# REGIONAL REVIEW FINDING

**Name of Proposal:** Palisades Development

**Review Type:** Development of Regional Impact

Preliminary Report:	November 3, 2006	<b>DEVELOPMENT OF REGIONAL IMPACT REVIEW REPORT</b>	Project:	Palisades #1152
Final Report Due:	December 3, 2006		Comments Due By:	November 17, 2006

**TITLE:** GRTA DRI SITE PLAN

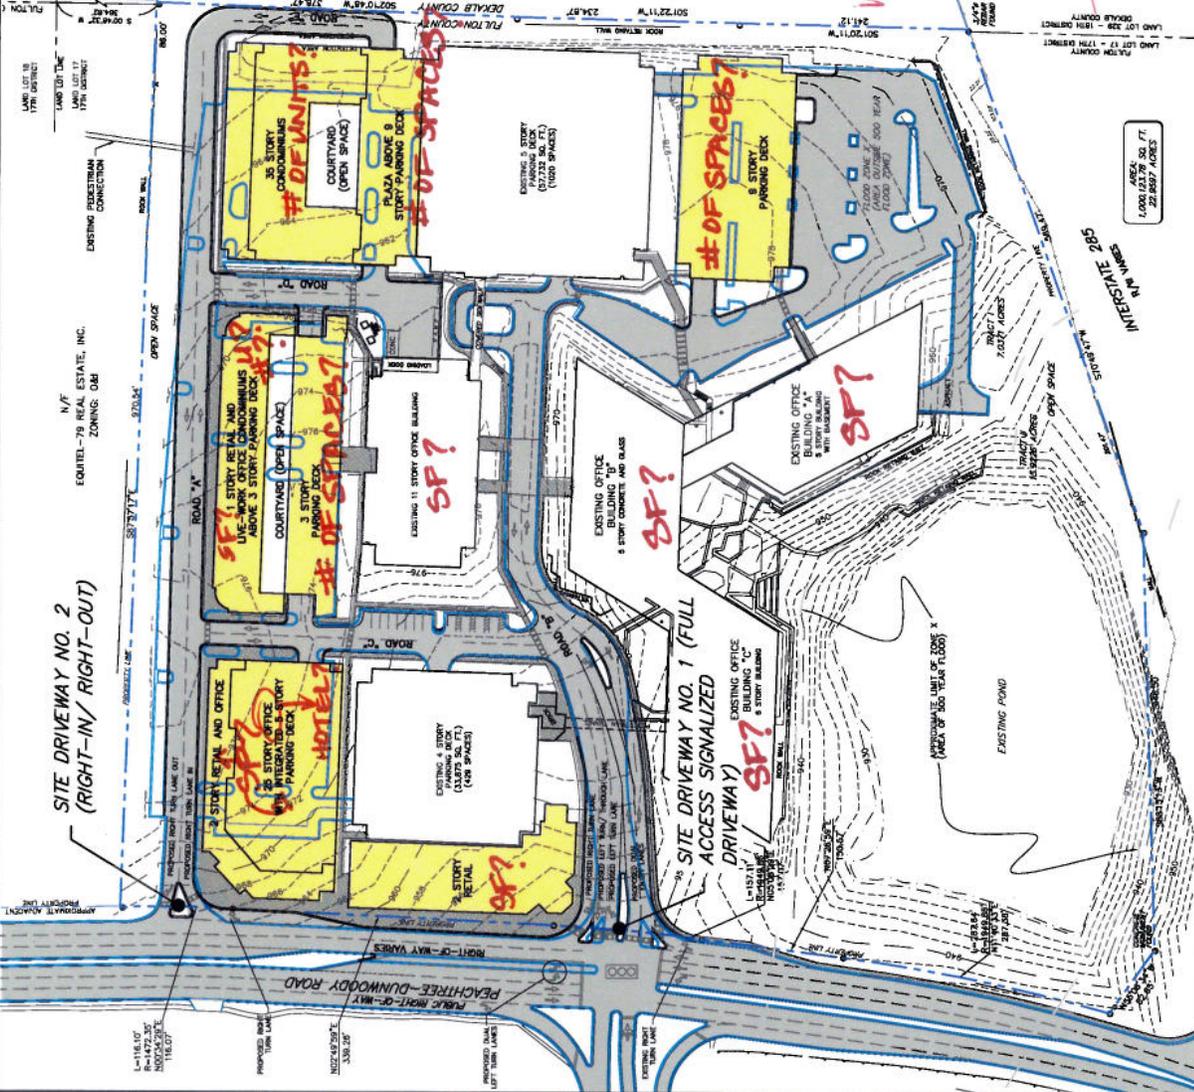
1. The hotel and townhouse uses listed in the "Land Use" and "Parking Summary" tables are not clearly identified on the site plan submitted.
2. The "Parking Summary" table is incomplete (Provided Spaces section).
3. The square footage of individual existing structures is not provided on the site plan.
4. The square footage/number of units for individual proposed structures is not provided on the site plan.
5. The number of parking spaces in each of the proposed decks is not provided on the site plan.

1. Mixed use development standards as required by Section 8.2.3, *Development Standards* shall be detailed on the site plan to include -
  - a. Proposed front, side, and rear yard setbacks.
  - b. Proposed internal setbacks, separations, landscaping, and buffering between uses.
  - c. Proposed minimum heated floor area for residential units.
  - d. Proposed 20% common outdoor area [to be maintained by property owner(s)].
2. Landscape strips as required by Section 4.23.1, *Minimum Landscape Strips and Buffers* shall be detailed on the site plan -
  - a. Front: 20 feet.
  - b. Side: 5 feet.
  - c. Rear: 10 feet.

3. Noise Study Report as required by Section 28.4.7, *Noise Study Report*.
4. Site plan revisions as noted on the enclosed Form F, *Site Plan Checklist*:
  - a. Posted speed limits on all adjoining roads.
  - b. Square footages of existing buildings.
  - c. Required and/or proposed setbacks.
  - d. Required landscape strips, undisturbed buffers, and any other natural areas as required or proposed.
  - e. Required, existing, and proposed parking spaces; Loading and unloading facilities
  - f. Proposed stormwater management facilities.
  - g. Tree lines, woodlands, and open fields on subject site (including specimen trees that will be affected by the proposed development).
  - h. Entrance site distance profile assuming the driver's eye at a height of 3.5 feet.
5. Two (2) full size copies of the revised site plan and one (1) reduced size (8 ½" x 11") copy.

Please find enclosed a redlined copy of the proposed site plan; a copy of Form F, *Site Plan Checklist* with deficiencies noted; a copy of the preliminary departmental comments from the August 1, 2006 Focus Meeting; and a copy of the required shared parking calculation as determined by the city.

TITLE: **GRTA DRI SITE PLAN**

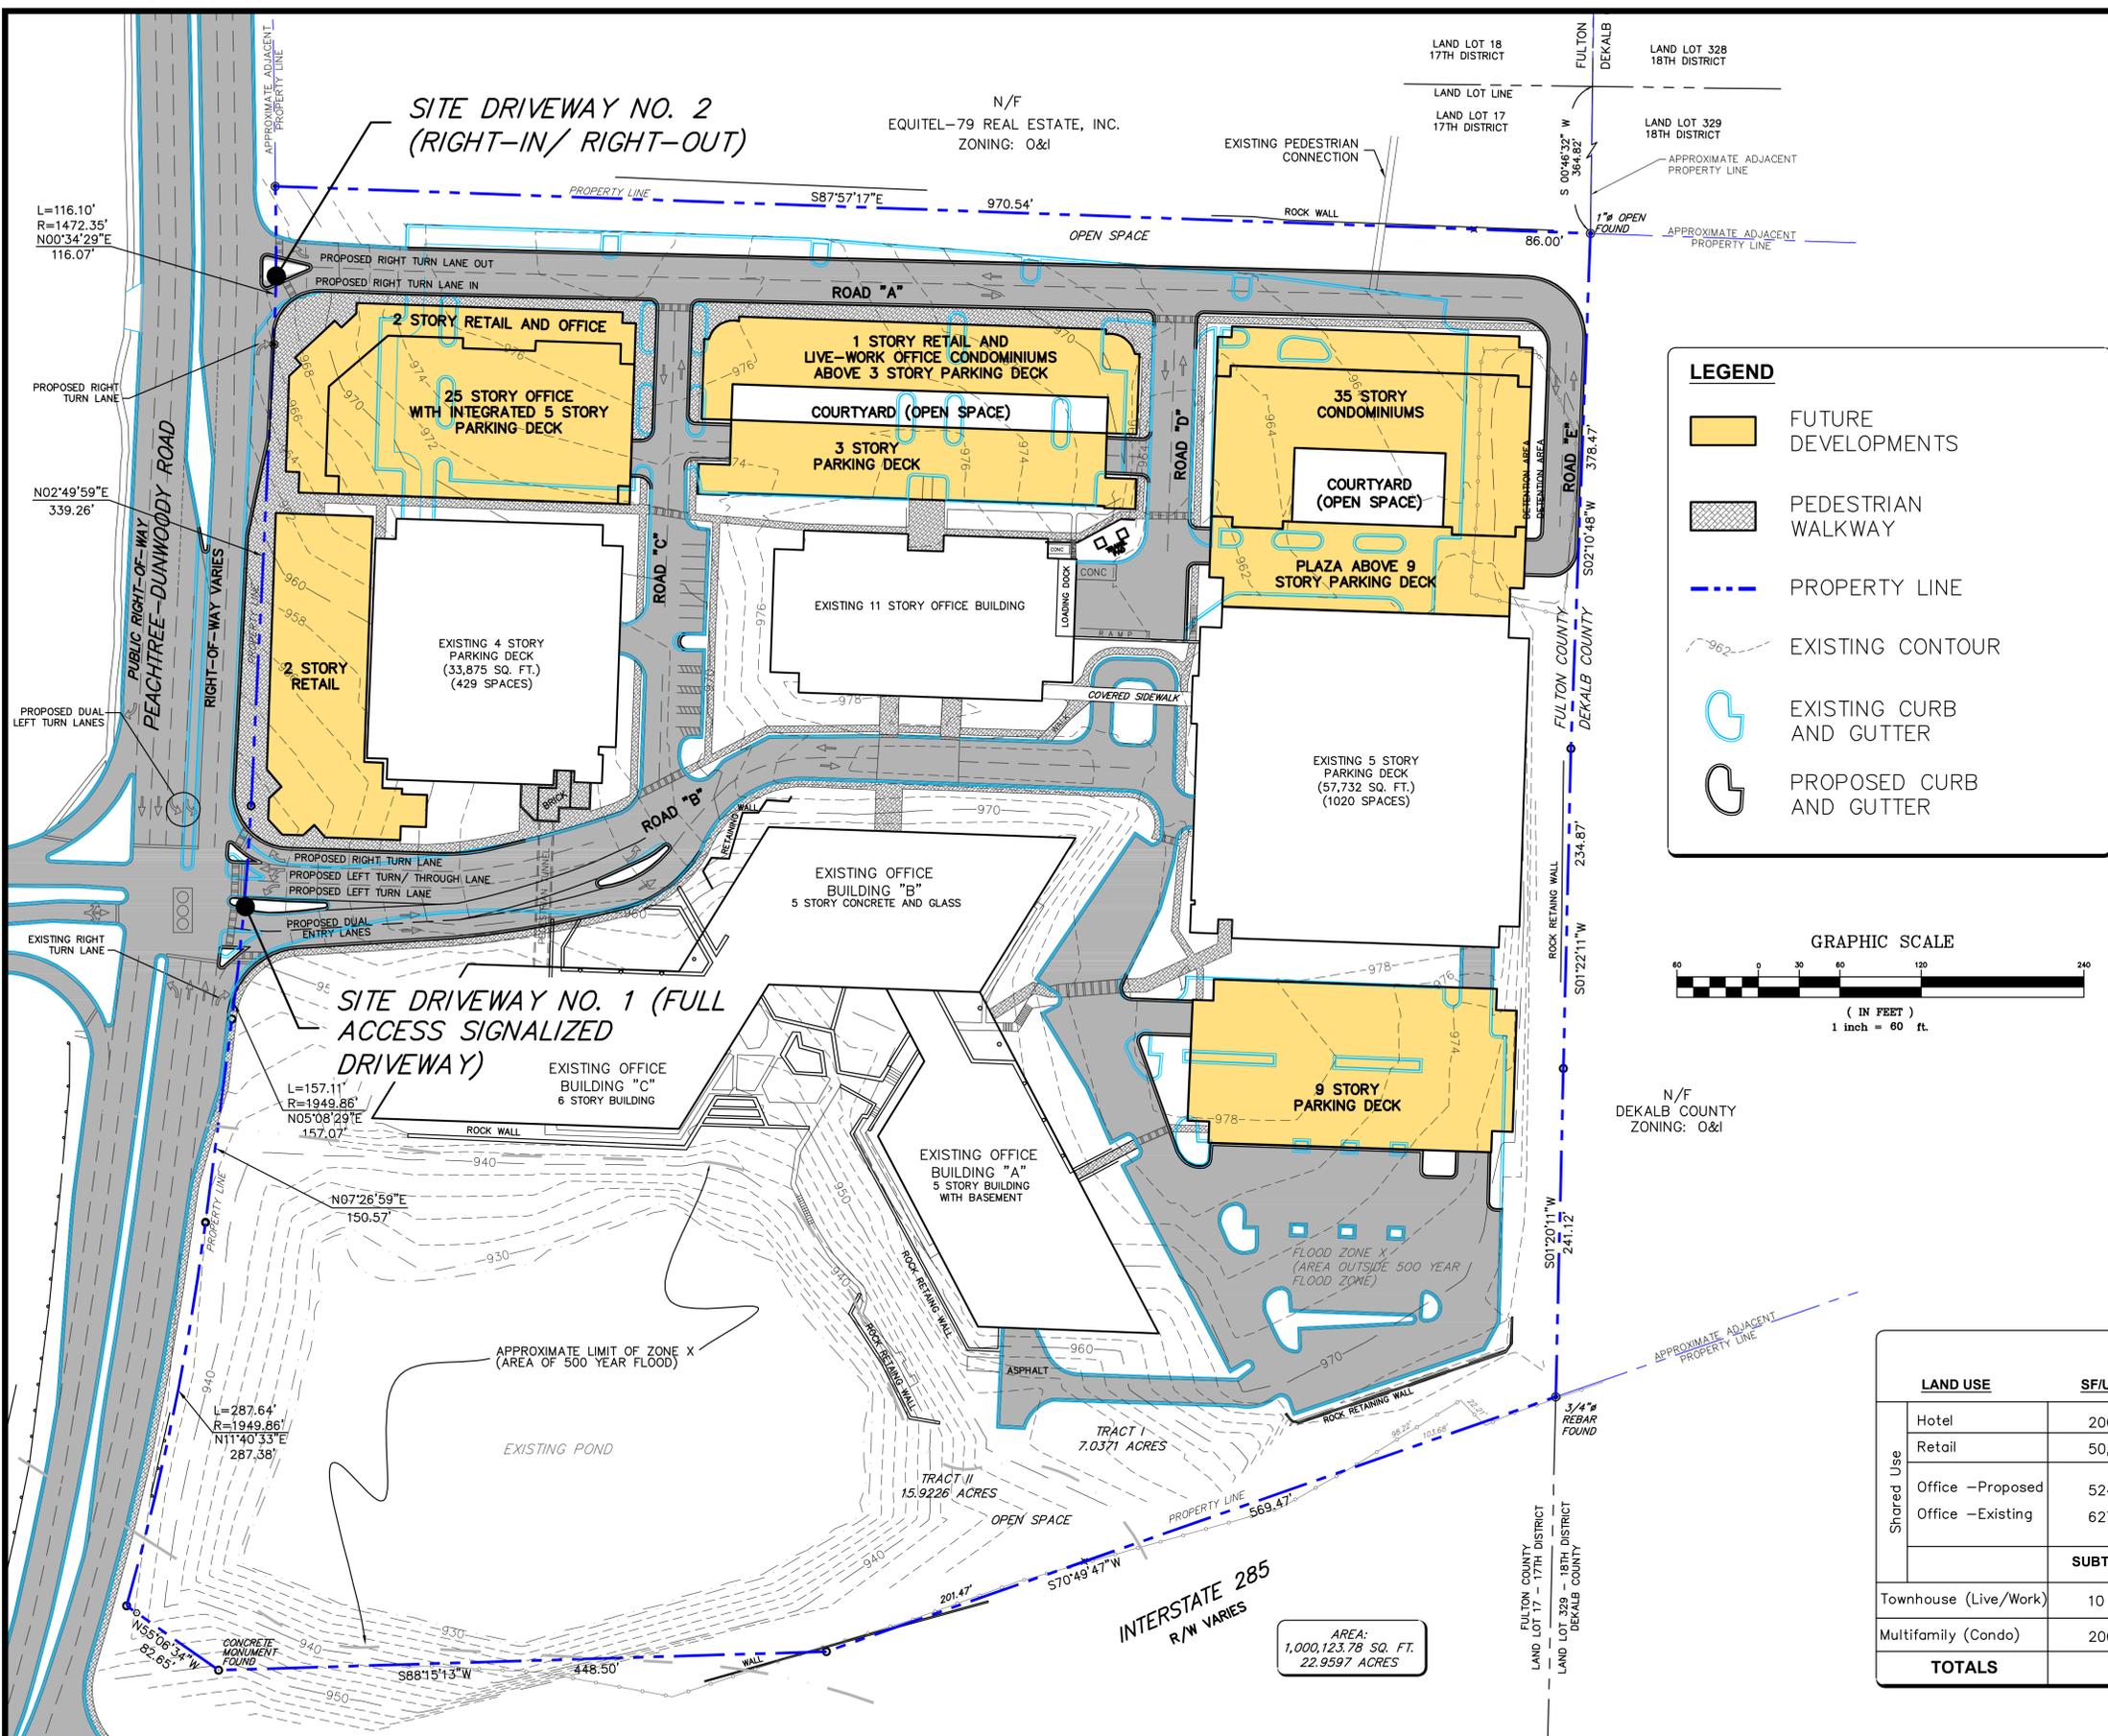
The Dunwoody MARTA Rail Station is located within a 1,900 ft walking distance of the site. The revised site plan identifies the location of an existing pedestrian connection into the parcel immediately north of the proposed development which allows the Dunwoody MARTA Rail Station to be accessible within the identified 1,900 ft walking distance. This existing pedestrian connection appears to be narrow, possibly difficult to see and includes no direct connection into the pedestrian network included in the proposed project.

It is strongly suggested that a mid-block cross walk be provided across Road A to link the existing pedestrian connection to the pedestrian network of the proposed project and that the developer work with the adjacent parcel owner to the north to upgrade the existing pedestrian connection to ensure adequate lighting and visibility are available. Additionally, it is suggested the developer provide directional signage to encourage the use of this pedestrian connection to reach the Dunwoody MARTA Rail Station.
